Save Coral Bay, Inc.  
9901 Emmaus  
Coral Bay, St John, USVI 00830

Re: **SAJ-1982-05019 (SP-JCM)**  
**Sirius Marina, Coral Bay, St. John**

*In order to provide context for our comments, we have inserted our comments directly following the responses provided by the applicant. The text of the Army Corps letter is in **Bold Italics**, the text of the applicant is in blue Standard Font and the comments by Save Coral Bay are in Simple Italics and offset between green solid lines.*

Re: SAJ-1982-05019 (SP-JCM)  
Sirius Marina, Coral Bay, St. John

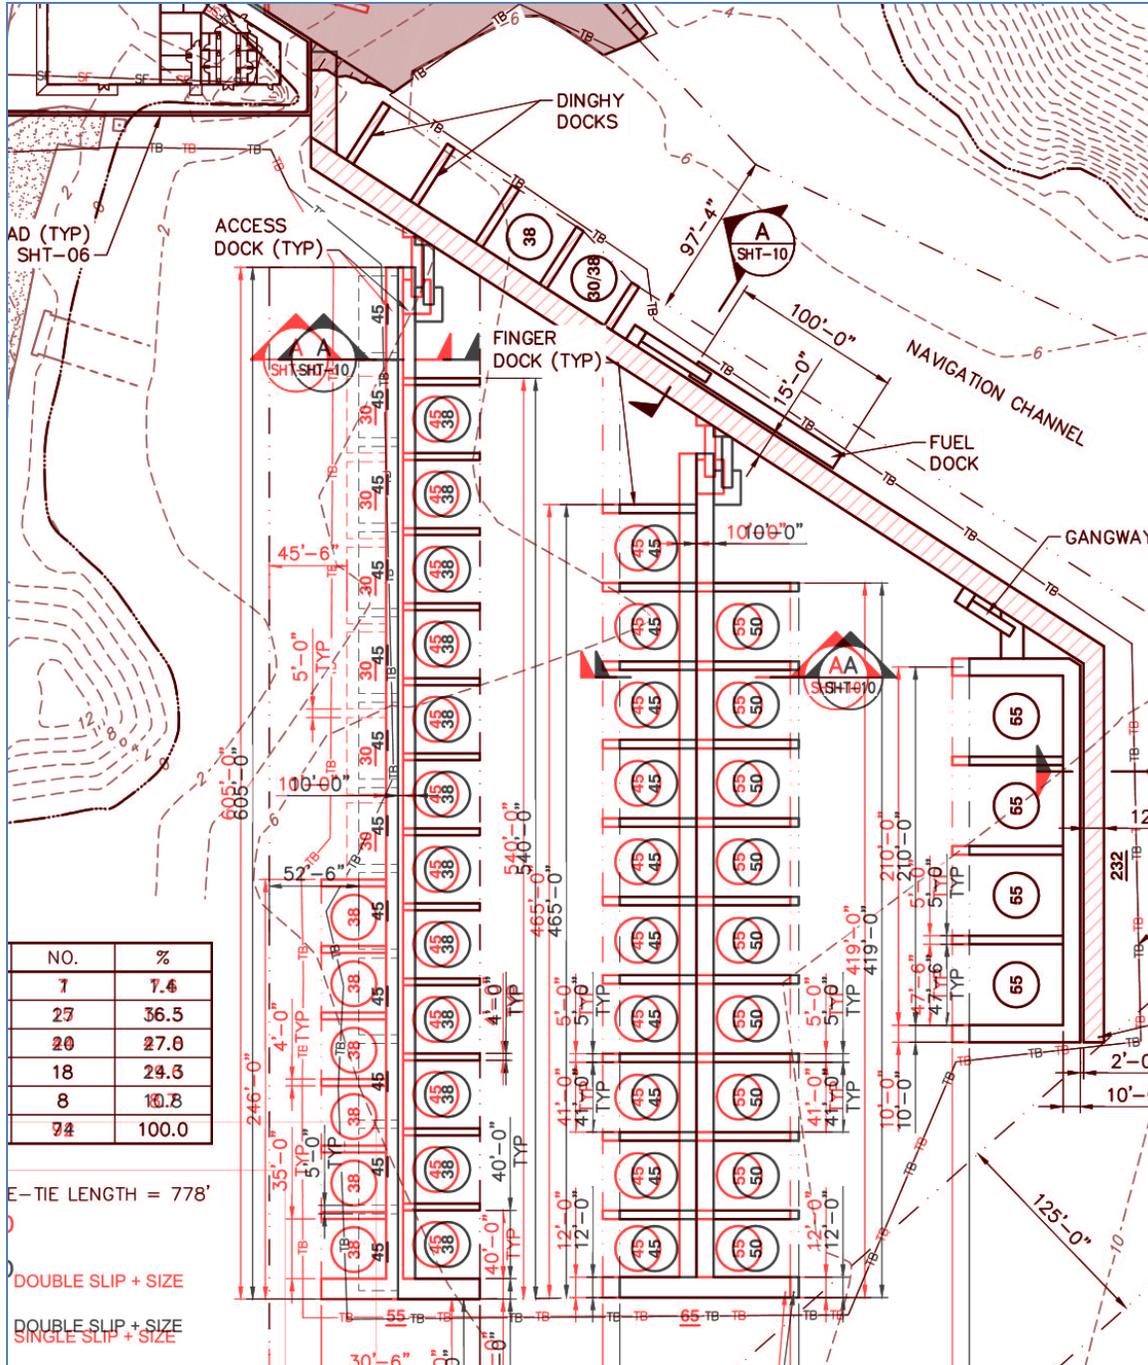
*The next illustration is an enlargement of the portion of the overall marina plan focusing on the in-water marina structures. Again, the new design is in red and the prior design is in black.*

This composite overlay drawing is difficult to decipher because of the dimension lines, but if one focuses solely on the actual marina structures – the access piers and the finger piers – the following design changes are apparent:

1. The finger piers on the most southerly access pier (on the right side of the drawing, since North points roughly to the upper left hand corner of this drawing) have been extended by 10' in order to accommodate larger boats. The original design had slips for 55' boats on this

2. The two most northerly access piers (on the left side of the drawing,) have been shifted approximately 10 feet towards the shoreline, as mentioned above. This is due to a combination of longer finger piers for larger vessels, and narrower alleys between the piers, for a net shift of 10' towards the shoreline.

3. The most northerly access pier, the one closest to the shoreline, has been modified by addition of seven finger piers to accommodate double berths for 38' boats. The prior plan did not have any finger piers between the northernmost access pier and the shoreline, and the entire length of the pier was allocated for side-tied vessels.

4. The alley between the finger piers of the middle access pier and the northern access pier has been reduced 10 feet in width. It was 82' wide in the prior plan and has been reduced to 72' in the current plan. The alley between the finger piers of the most southern access pier and the middle access pier has been reduced by 5 feet in width, from 100' to 95' in the new design.

First, the applicant has increased the overall size of the in-water marina by accommodating slips for 65' boats in the revised plan, whereas the original plan was limited to 55' boats. The total number of slips has increased from 74 slips in the original plan to 86 slips in the revised plan (not inclusive of side-ties). This increase of 16% in the number of slips results in increased impacts due to construction, pilings, and shading.

*Second, while increasing the slip sizes, the applicant has reduced the navigational alleys between the slips, so larger boats must navigate narrower alleys. In fact, in the original plan all of the alleys were sufficiently wide for two boats, end-to-end, to fit in the alley (e.g. the previous 82' alley was between 45' slips and 38' slips, for a combined length of 83'). In the new design the alleys have become narrower while the slips have become longer (e.g. the new 72' alley is between two 45' slips for a combined length of 90').*

*Third, the northernmost finger piers in the new plan, pointing directly at the shoreline, are in water depths of 4' to 6' based on the bathymetrics provided by the applicant. These slips, which are designed for 38' boats, will require the vessels to navigate in water depths as shallow as 4 feet in order to enter and exit the slips, which are oriented with their entrances toward shallower water, so a bow-in entrance requires the deepest part of the vessel (the engine or propellers) to be in the shallowest water. A typical 38' motor boat has a draft of over 3', so this configuration will result in extreme propeller wash and possible groundings. The new slips in the shallowest portion of the marina footprint are almost certainly not feasible as designed.*

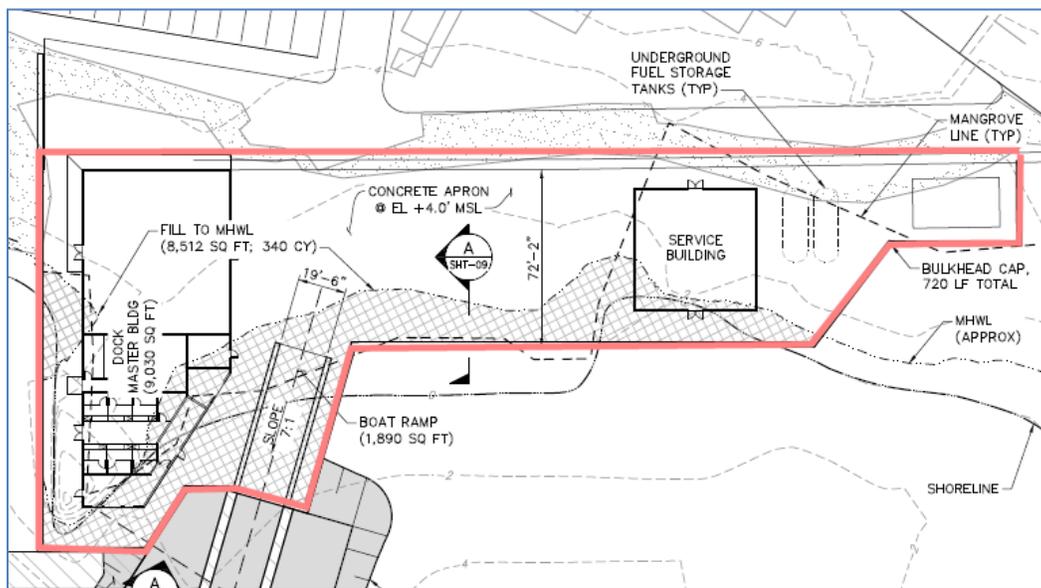
*These figures neglect the fact that traffic is not spread evenly over a 24 hour period. It can be anticipated that at least 80% of the total marina traffic load will occur during the peak morning and peak evening hours, e.g. from 8:00 – 10:00 am and from 4:00 – 6:00 pm, a four hour period. This would then mean that 80 vehicles are anticipated over a four hour period, or 20 vehicles per hour. If the peak design capacity of Route 10 is 100 vehicles per hour, this demand is 20% of the entire capacity of the roadway. We are also concerned that this estimate does not apparently include the demands of the closely related 89-room Resort and Hotel. No estimate of traffic loading has been provided for that component of the project.*

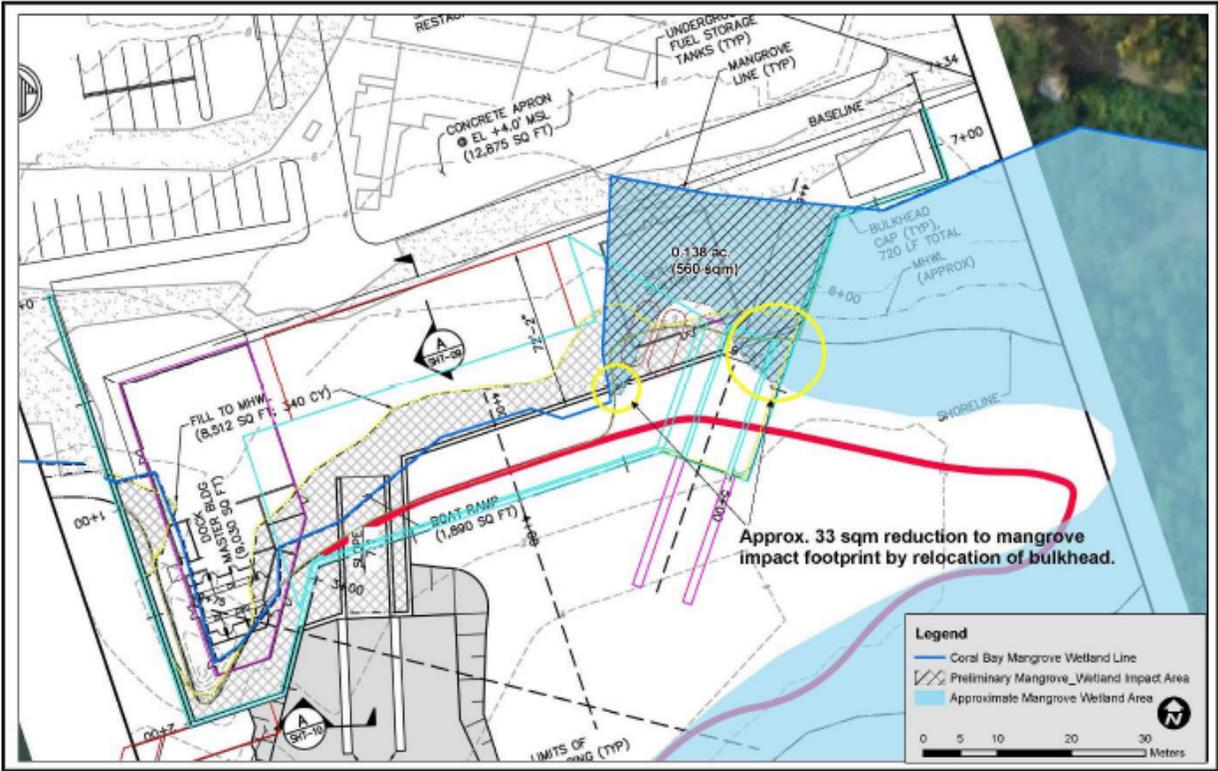
*We have compared the "new bulkhead location" with the bulkhead depicted in the original Army Corps permit drawings. The two bulkheads are overlaid in the composite image below (the bright green line is the "new bulkhead" and the light red line is the original bulkhead – where they overlap it appears as a darker green):*

*bulkhead) severs the connection with the salt pond and isolates those waters. In this composite drawing the salt pond is outlined in Blue, the tidal mangrove channel is labeled "MC" and outlined in Yellow, and the "New Bulkhead" is the bright Green line. The bulkhead completely severs the tidal connection between the salt pond and the harbor, isolating this body of water.*

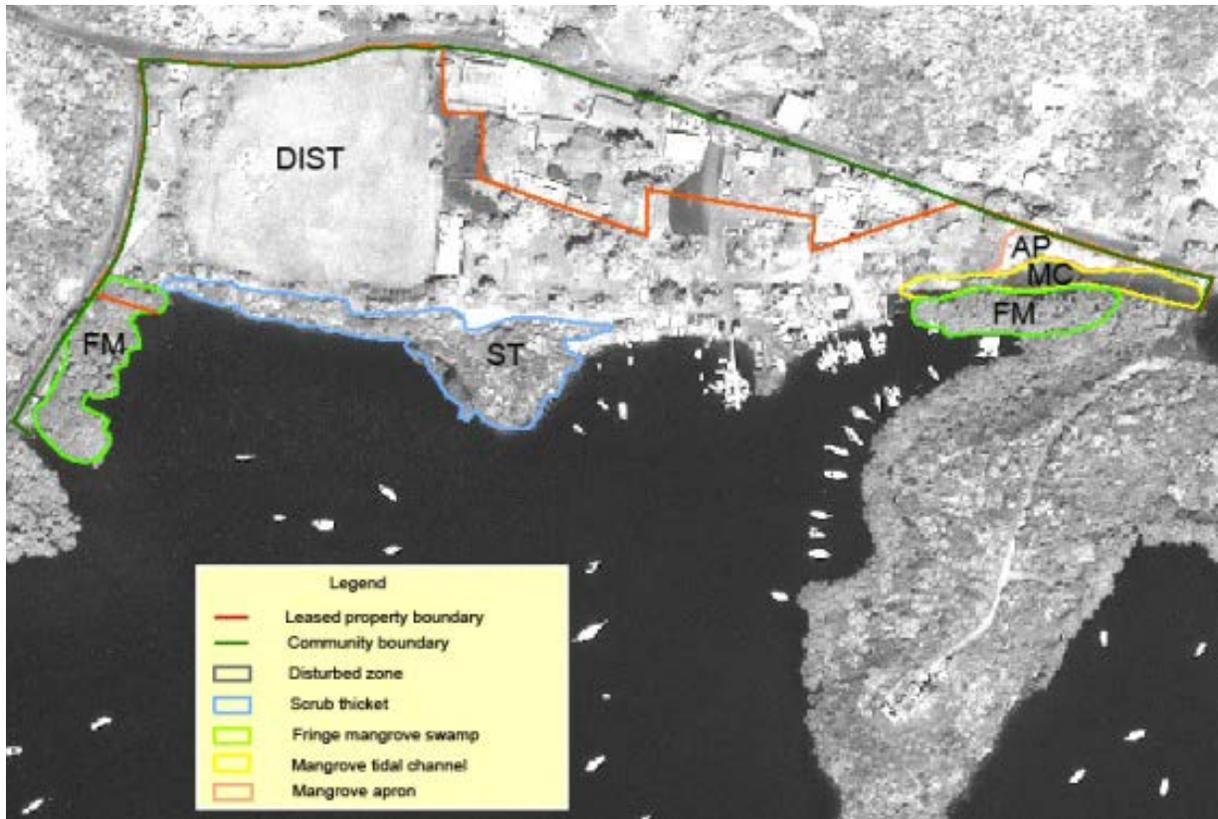
The mangrove tidal channel connecting to the salt pond is well known to the owners of Usher Cay. In historic times there was a stone culvert or bridge traversing the channel on the road leading to the house on Usher Cay. Remnants of these stone works are still visible. The road is frequently flooded during high tides, providing replenishment to the waters of the salt pond.

The proposed location of the bulkhead and concrete apron would totally cut off the channel from the waters of Coral Bay, thereby isolating the salt pond.

The illustration above does not include the extensive mangrove propagules which are seen on virtually the entire northern shore of the creek. We have provided photographic evidence of this mangrove growth previously. As a consequence of the issues discussed above we believe the applicant has significantly underestimated the impact to mangroves.

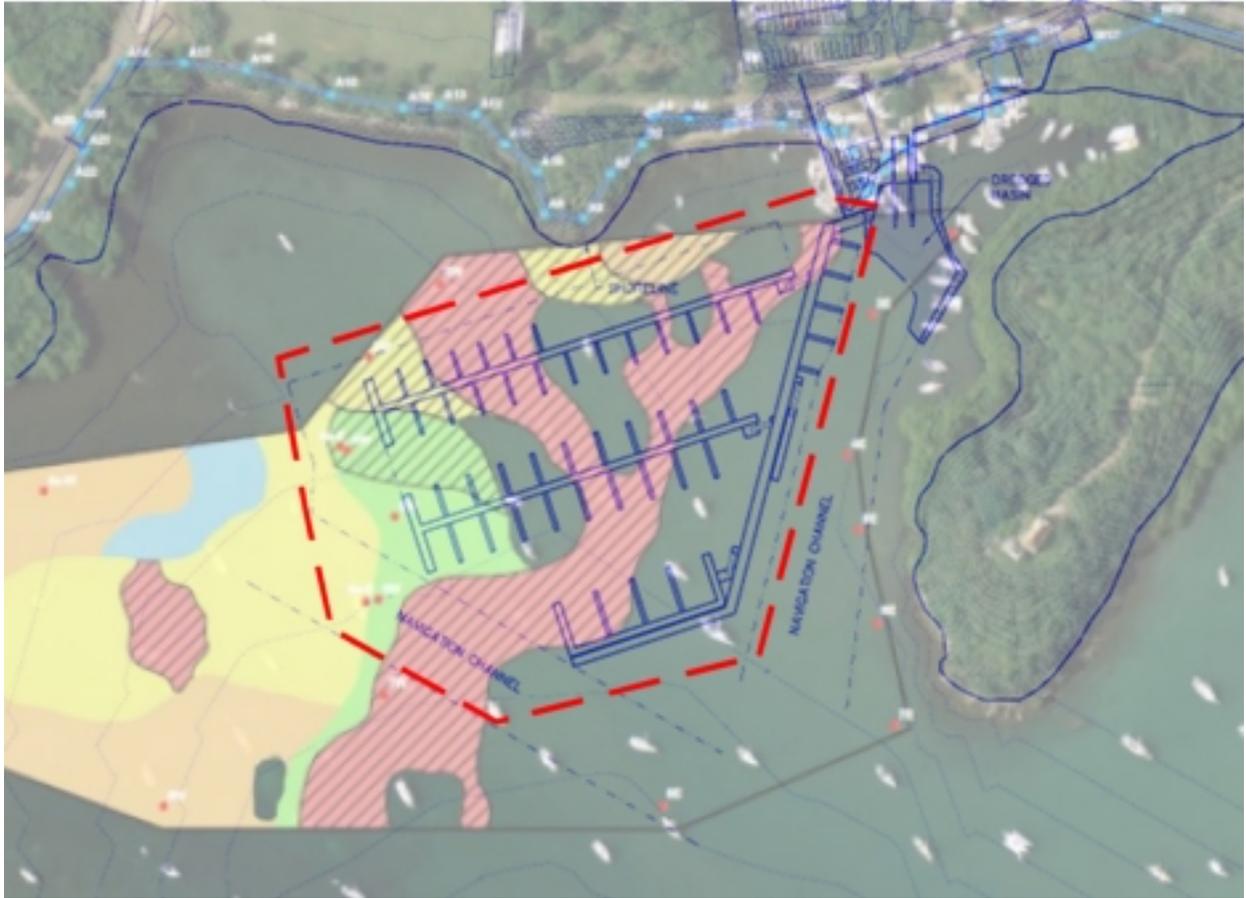
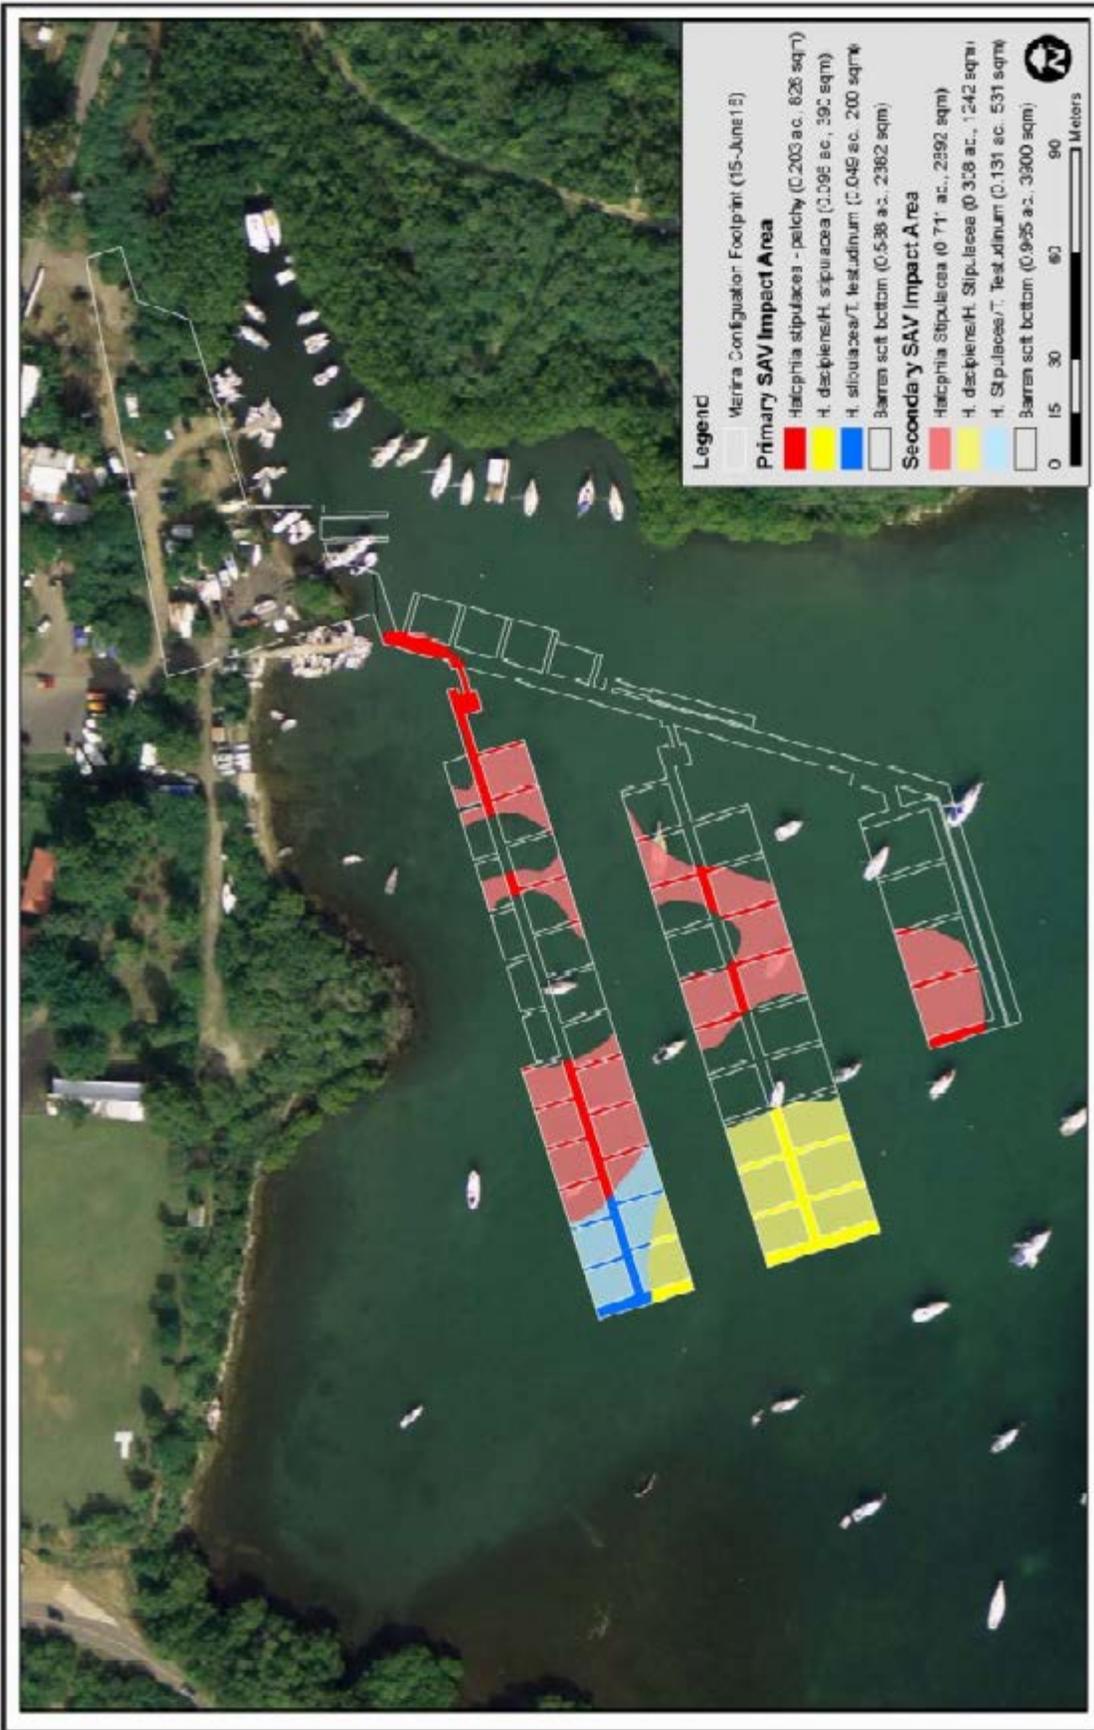
*The illustration provided by the applicant restricted consideration of benthic impacts to the areas directly beneath the fixed dock structures and slips. The illustration below includes the entire in-water project footprint and the applicant's sea grass map for that area:*

*Based on this comparison of the sea grass map with the project footprint, we conservatively estimate the impact on sea grasses within the entire project footprint at roughly 5 acres or approximately ten times the area estimated by the applicant.*

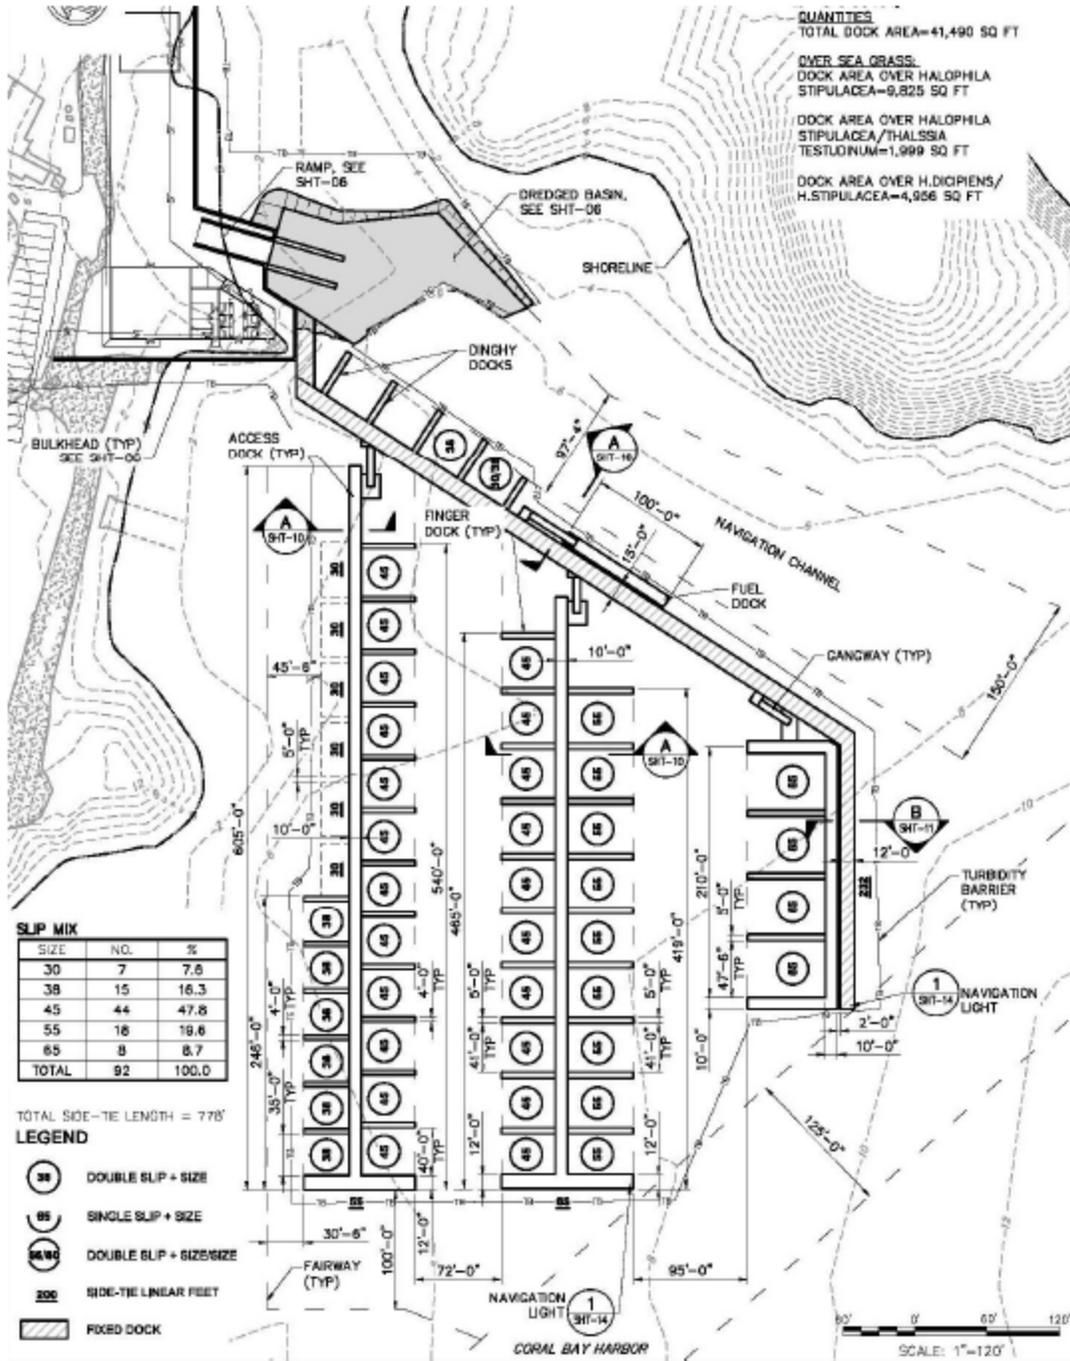
*The fact that the docks have been moved closer to the north shore of Coral Bay is troubling. This move places the entire structure in shallower water and further constricts the water between the marina and the shoreline. We have commented on this change elsewhere in these notes.*

*The list of project features, above, includes items that are not shown in sufficient detail for comment, or not shown at all, in the revised drawings submitted with the applicant's response. For example, the "Parking" is not described in terms of size, construction, storm water management, and in fact it isn't clear if it is even in the current plans (e.g. it doesn't fully appear in the "Marina Layout" drawing below, only as a partial set of lines).*

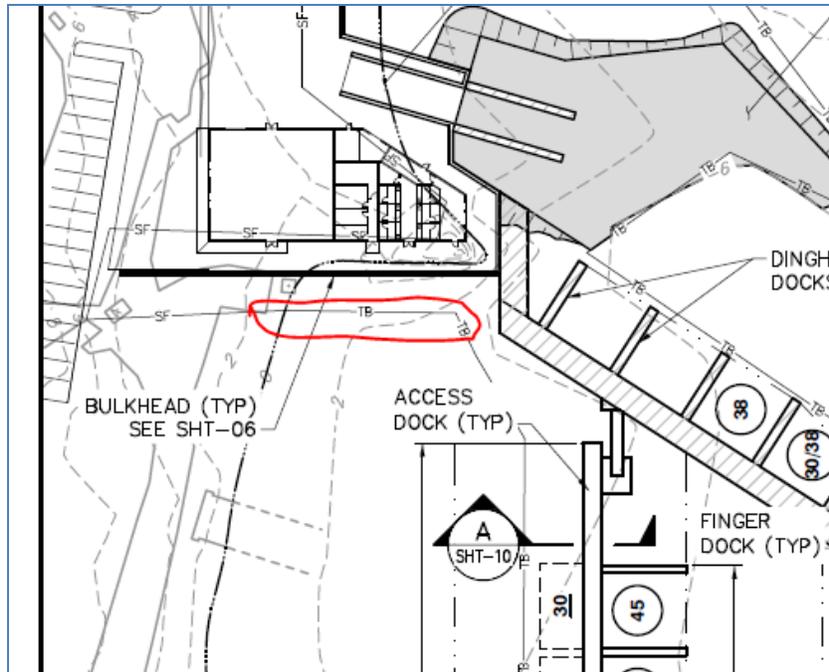
The revised drawings submitted by the applicant do not agree with the statement above. The excerpt below is from Sheet 04 of the revised drawings ("SHT-04 Existing Conditions and Demo Plan"), and it indicates that the dock will be demolished and removed:

Finally, even if the historic dinghy dock were to remain, based on the proposed design the dock would be virtually unusable. The water access to the historic dock from the existing navigation channel has been blocked by the placement of the main pier.
